Access Compliance Report Public Rights-of-Way (Curb Ramps)

Main Street: SANTO_TOMAS_ST Cross Street: SANTA_ANA_AVE Location: W

ADA ID: RPAT220128164805 Ramp Type: Type 4 - Parallel Initial Pass/Fail: Pass Overall Compliance: No Severity Score: 34

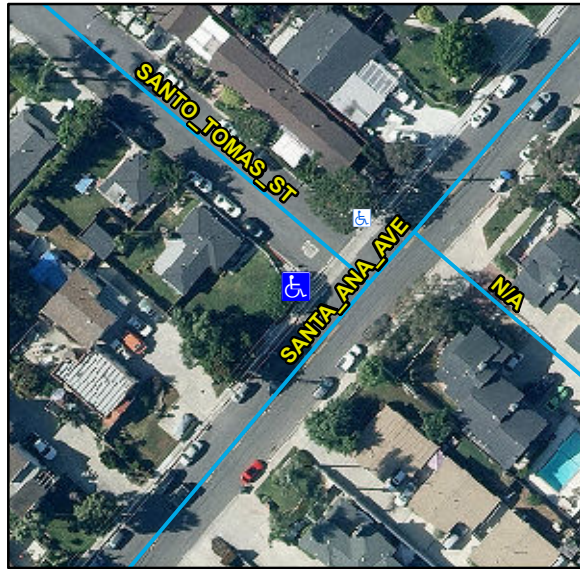
Remove & Replace Entire Ramp. Remove & Replace Gutter. Replace Spandrel.

R302.7, STD 122-2, R305, R302.7.2, R304.5.4, R304.5.3, STD 1115
